ADDENDUM NO. 4

TOWN OF VINALHAVEN, MAINE

PUBLIC WORKS GARAGE & SALT STORAGE PROJECT

Prepared by:
WOODARD & CURRAN INC.
41 Hutchins Drive
Portland, ME 04102
Tel.: (207) 774-2112
Date: June 19, 2020

SK1 – METAL BUILDING ROOF SECTION

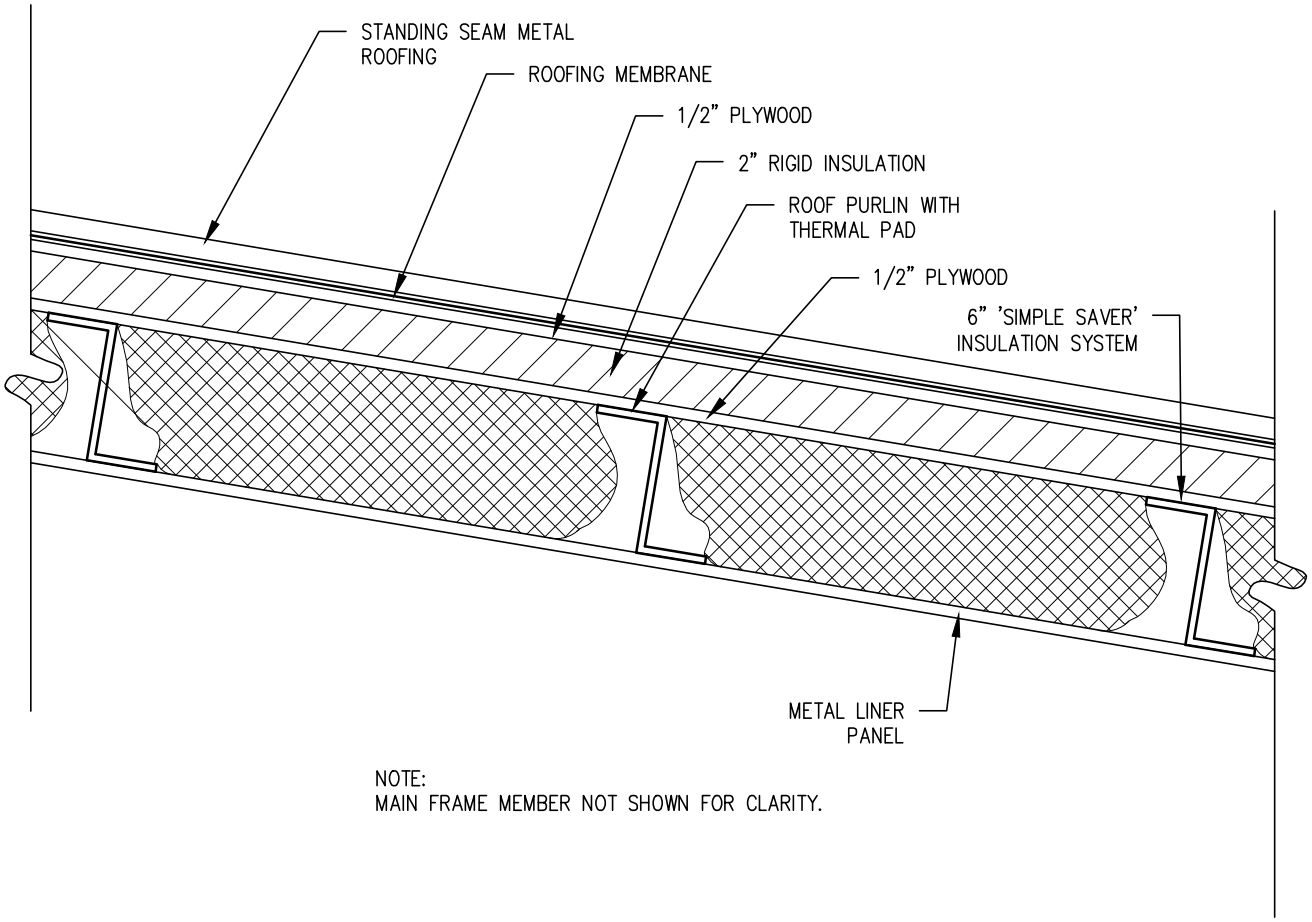
Please provide more details regarding the Ceiling/Roof insulation? Lots of details about the various Wall Types. No details regarding the Ceilings/Roof.

The Specs call for R-30 Batts above the Suspended Ceilings. What about the rest?

Can you provide any cross sections the two sections with different roof lines? I need to see wall and ceiling heights and ceiling profiles.

Answer: Refer to attached Roof/Ceiling Details (SK1 – SK4).

Answer: Refer to attached Roof/Ceiling Details (SK1 – SK4).

Answer: Refer to attached Roof/Ceiling Details (SK1 – SK4). Refer to drawings for ceiling heights.
